DRAINED RESIDUAL STRENGTH OF COHESIVE SOILS^a

Discussion by Robert W. Day,³ Fellow, ASCE

Discussion by Milan Maksimović⁴

Closure by Timothy D. Stark,⁵ Associate Member, ASCE, and Hisham T. Eid,⁶ Student Member, ASCE

FIG. 9. Slide at Jackfield, England [Reproduced from Bjerrum (1967), Originally from Skempton (1964)]

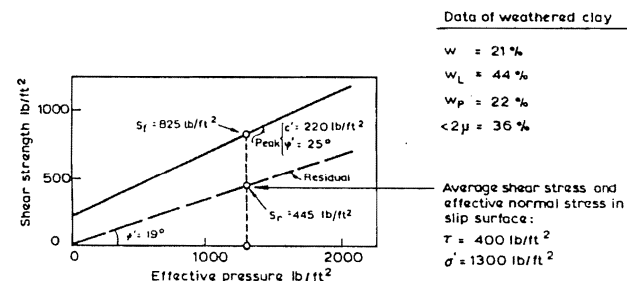
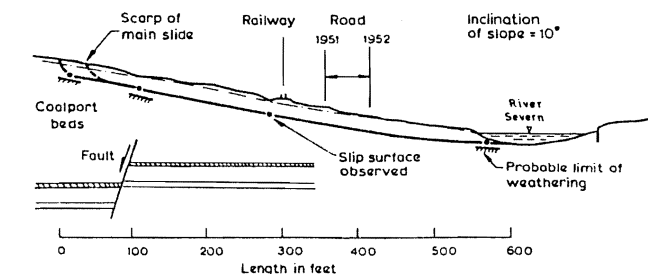
Fig. 9 is reproduced from Bjerrum (1967) and shows the slide at Jackfield. The residual friction angle from laboratory testing is 19° and the back-calculated value from stability analyses is 17° (table 1, Bjerrum 1967). Using the authors correlation (Fig. 4), the residual friction angle is 23°.

FIG. 10. Interpretation of Test Results: (a) Nonlinear Failure Envelope; (b) Relationship between Secant Angle of Residual Shearing Resistance and Effective Normal Stress in Linear Scale

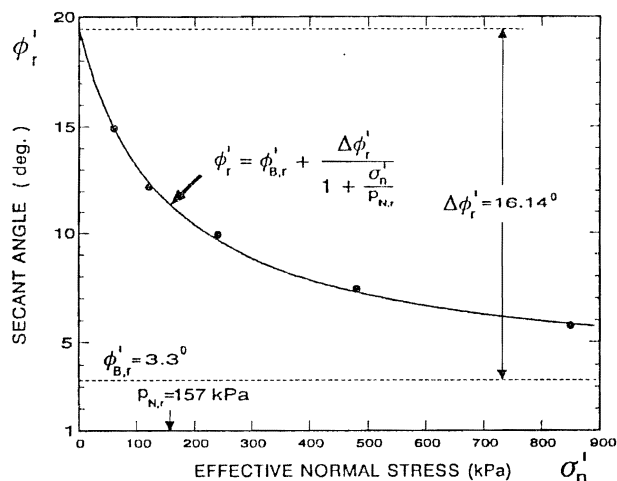
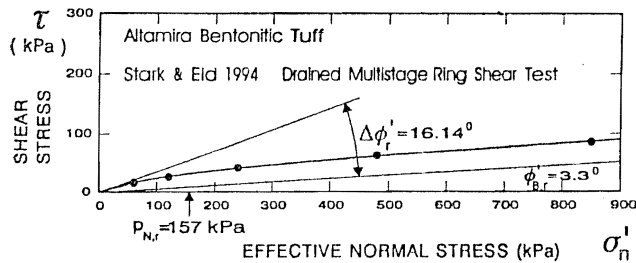
The residual strength envelope and the variation of ϕ'_r with the stress level in linear and the semilog plot are shown as Fig. 10 and Fig. 11. The curve fits the data with remarkable accuracy. Unfortunately, other 32 listed test samples could not be processed in the same manner, because the complete numerical database in the paper is missing. It is the discussor's experience (Maksimović 1993) that any correlation on the nonlinear shearing strength of soil should be presented in terms of parameters ϕ'_B , $\Delta\phi'_r$, and p_N . The only correlation that explicitly describes the nonlinearity of the residual failure envelope in a normalized form known to the discussor is the one by Skempton (1985). The result of regression analysis of the mentioned numerical correlation performed by discussor is that for the range of values $(\phi'_r)_{100} = 6^\circ \div 16^\circ$ the value of the mean angle pressure is practically constant $p_N \approx 120$ kPa. The discussor will adopt this value, and focus only on the soil type of high plasticity [liquid limit (LL) > 50%]. After some iteration on the author's correlation, reviewing of results summarized by Lupini et al. (1981) and personal data-

FIG. 11. Relationship between Secant Angle of Residual Shearing Resistance and Effective Normal Stress in Log Scale

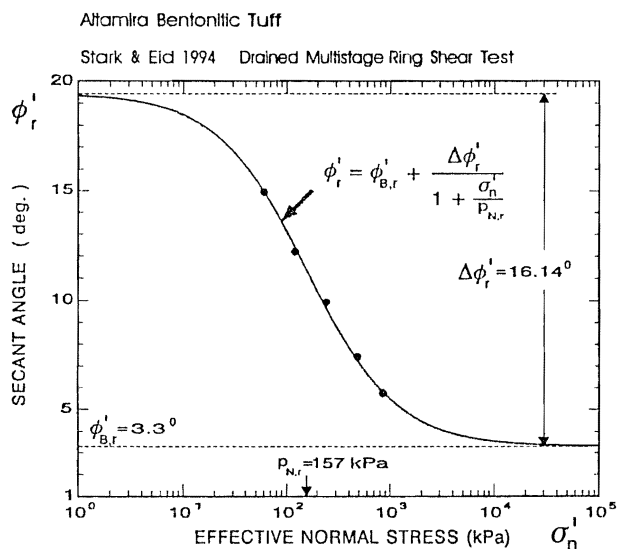
negligible difference, but the line in Fig. 4 presumably corresponding to 400 kPa is about 1° to high. The authors have applied linear interpolation between the values for 100 kPa and 700 kPa. The linear interpolation in semilogarithmic plot is much more appropriate (Fig. 11).

FIG. 12. Alternative Correlation: Relationship between Parameters for Nonlinear Envelope of Residual Shearing Resistance and Liquid Limit

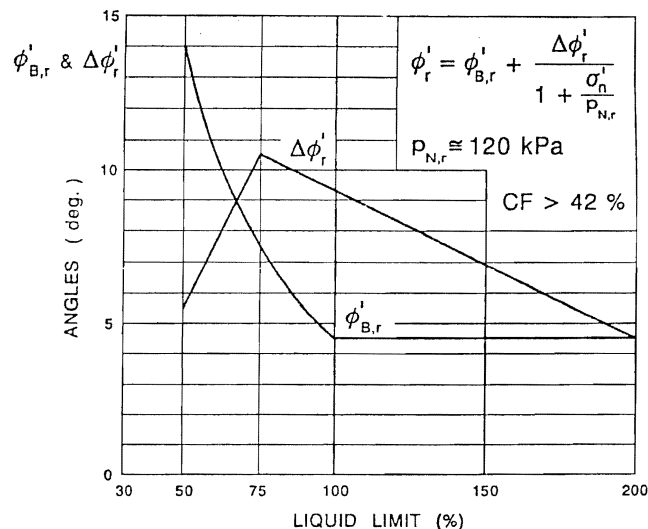
base, an alternative correlation is derived for clays with $CF > 42\%$ using parameters, $\Delta\phi_r^i$, $\phi_{B,r}^i$, and $p_{N,r}$ as shown in Fig. 12. The main advantage of such an approach is that the angle of residual shearing resistance is described as a continuous function of both the liquid limit and the stress level. In order to check both correlations, the variation of the secant angle with the normal effective stress for a set of values of liquid limit ranging from 50% to 200% is drawn in Fig. 13. The correlations between residual strength and soil index properties cannot be general due to the following findings:
